City of El Paso - City Plan Commission Staff Report

Case No: SUSC14-00002 Montecillo #4 Replat A (Reconsideration)

Application Type: Resubdivision Final **CPC Hearing Date:** October 8, 2015

MONTECILLO UNIT FOUR REPLAT 'A' MONTE VALUE MONTE SOL MONTECILO

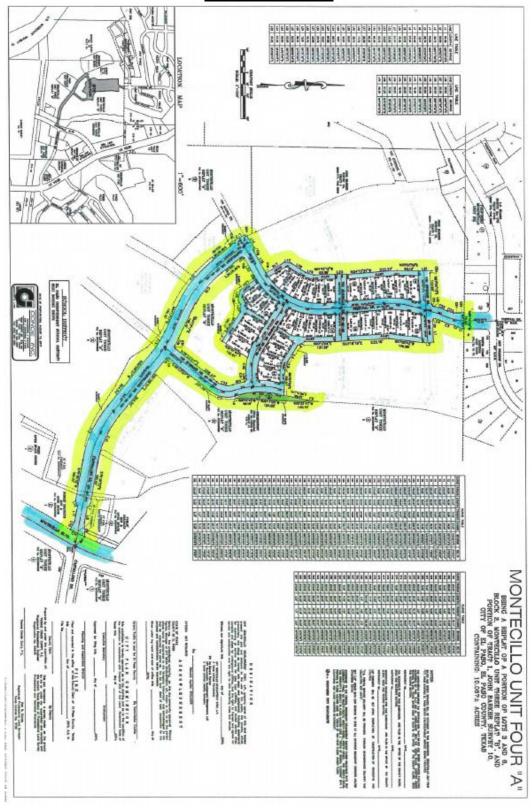
1. EPDOT review and approval is required for proposed ROW slope easements.

- 1. Promontory area shall be developed per approved Regulating Plan and Title 21 Standards.
- 2. Developer (EPT) in addition to the approved Regulating Plan improvements to the Promontory area agrees to provide a Gazebo, some park benches as well as a garden wall 4'- 6' high combination rock wall / wrought iron abutting the arroyo.

2. The subdivision requires the extension of an 8-inch diameter water main along the alignment of Vin Castellano Dr. from the existing 8-inch diameter water main located on Castellano

- Drive (approximately 340-ft west of the intersection of Montecillo Dr. and Castellano Dr.) to connect to the existing 8-inch diameter water main along Festival Dr.
- 3. The subdivision will be located within an intermediate pressure zone. Private water pressure regulating devices will be required at every lot within the intermediate pressure zone. The Developer shall include in the sale of contract documents that the lot/home buyer shall acquire ownership of the above-described water pressure regulating devices to be located at the discharge side of the water meters. The lot/home buyer shall be responsible for the operation and maintenance of the above-described water pressure regulating devices.

4. The subdivision requires the extension of an 8-inch diameter gravity sanitary sewer main along Vin Castellano Dr. to connect to an existing 8-inch diameter gravity sewer main located within a P.S.B. Easement located across Vin Castellano Dr.
